From: Randy L. Melanson [/O=GM/OU=EXCHANGE ADMINISTRATIVE GROUP (FYDIBOHF23SPDLT)/CN=RECIPIENTS/CN=D9A7A37C26F5454EBA951042EE05399E-FZH6R6]
Sent: 9/20/2018 2:58:28 PM
To: Andrew Scheich [andrew.scheich@gm.com]
Subject: RE: 8 Speed RWD Shudder: ATF Data
Attachments: Dexron HP 9986509Oct2016_Performance Deficiencies(v1)_20SE18.pptx

Dexron HP 9986509Oct2016

Performance Specification GMW16974

Deficiencies

ATF Contamination on 3 day wear test

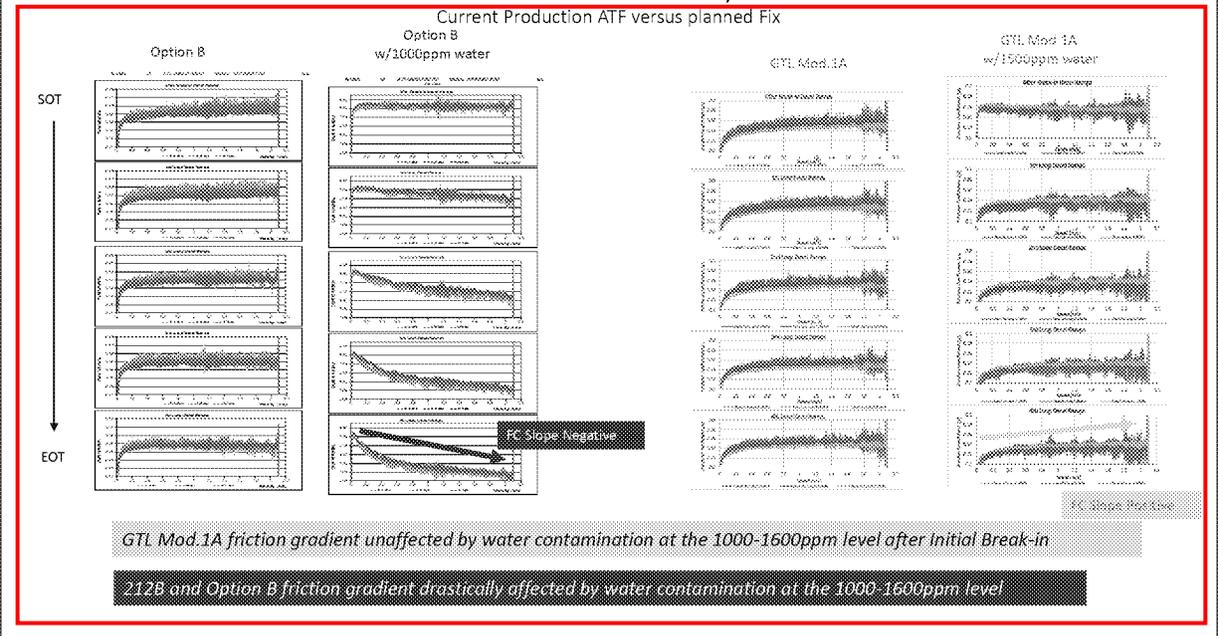
- 1.) What is Pass/Fail Criteria of GM Three (3) Day Wear Test? *EOT average slope between 0.35-1.02 m/s > -0.0049 s/m (original Grimmer line), however this was not in place when 212B was production released*
- 2.) Was 212B 1000ppm 3 Day Wear Test Report shared with us prior to SOP? *No, it was only after 2015MY shudder warranty incidents were noticeably concentrated in southern states that water was suspected as a contributor of degraded friction performance. Significant slope degradation noted at the 1000ppm level.*

Current Production ATF versus others historically

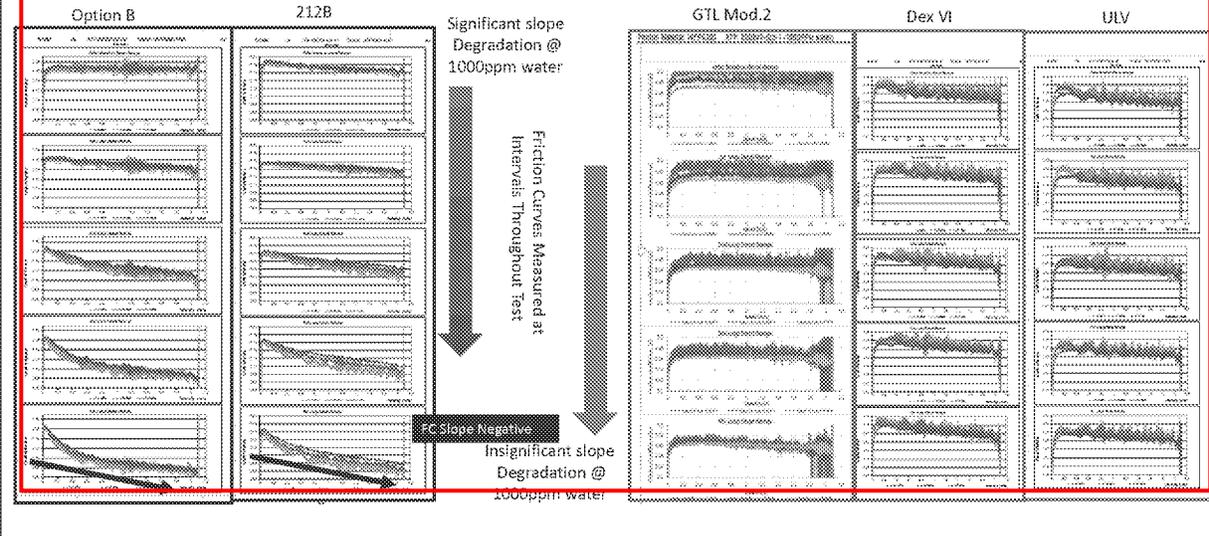
- Original 8 Speed ATF (212B) & Option B are highly sensitive to water.
- Seen in data below, as well as vehicle testing, and ATF field samples measuring water.

Vehicle Water Sensitivity

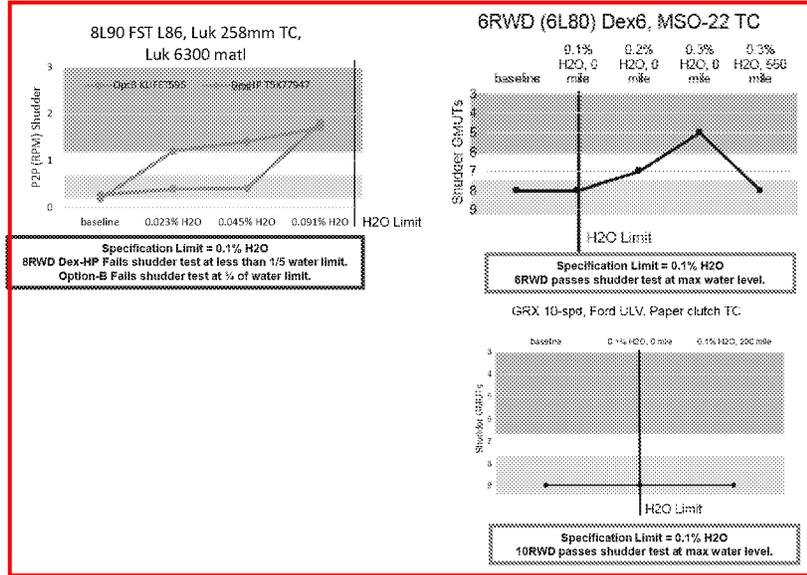
1.) What are the results of this test with either WFP6300 or BW6100 with and without 1000ppm of water? *Not sure, would have to ask Afton. However, I doubt this would have been done w/ 1000ppm water, and results would probably be ok w/ no added water.*

GMWEAR testing was done in 2016 w/ MS022 (carbon fiber) in base 212B, and results were similar to, maybe slightly worse than, in Dex VI
